Re: BP America Production Company  
Florida River Compression Facility  
Title V Permit – Renewal #1  
# V-SU-0022-05.00

**Enclosure - Response to Comments on the Florida River Compression Facility's  
March 28, 2008 Draft Title V Permit to Operate**

BP America Production Company  
Florida River Compression Facility  
Basin System Flow Diagram

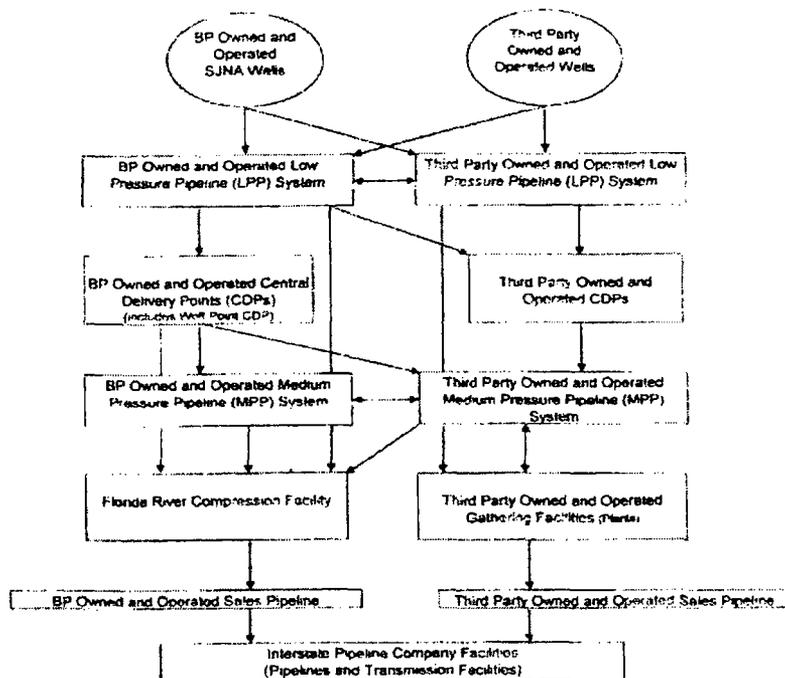
“BP gas” is transferred to third parties or vice versa, the gatherer takes custody of and assumes liability for the gas while in the gatherer’s possession, the gas is measured by the gatherer, and the shipper verifies those volumes with its own check meter.<sup>28</sup> The following process flow diagram illustrating the flow of gas in the field demonstrates the lack of a unique connection between BP facilities.<sup>29</sup>

While the entire NSJB gas field is highly integrated, the record shows that the individual well site operations, compression, and gas processing are conducted by completely separate and distinct equipment, such that gas metered at one well head can flow to several low-pressure gathering lines which may be owned or operated by BP or by other companies. Therefore, regardless of where the well site is located in relation to other emission points and regardless of who owns or operates those emission points, once the gas is pumped, it enters these intermediate pipelines, mixes with gas from several other companies, and is sent to various compressor stations and gas plants. Gas handled by Wolf Point is compressed and dehydrated, and then flows – via medium-pressure pipelines operated by BP or third parties – to Florida River or to other third-party-operated CDPs. Thus, Florida River can continue to operate regardless of whether Wolf Point or one, two, three, four, or all of the BP operated well sites were to shut down – and vice-versa.<sup>32</sup> The nature of movement and mixture of the gas product pumped from the wells in this field means that no one well site (or compressor station) is more interrelated to or dependent on Florida River than any other well site, such that operations at Florida River do not have an exclusive or dedicated interrelatedness with Wolf Point or the BP operated well sites.

Taking into consideration the complex and diverse gas movement among the facilities, as well as the lack of unique interdependence among the facilities, EPA has determined that the Florida River Compression Facility, Wolf Point Compressor Station, and BP's numerous well sites within the NSJB are not adjacent.
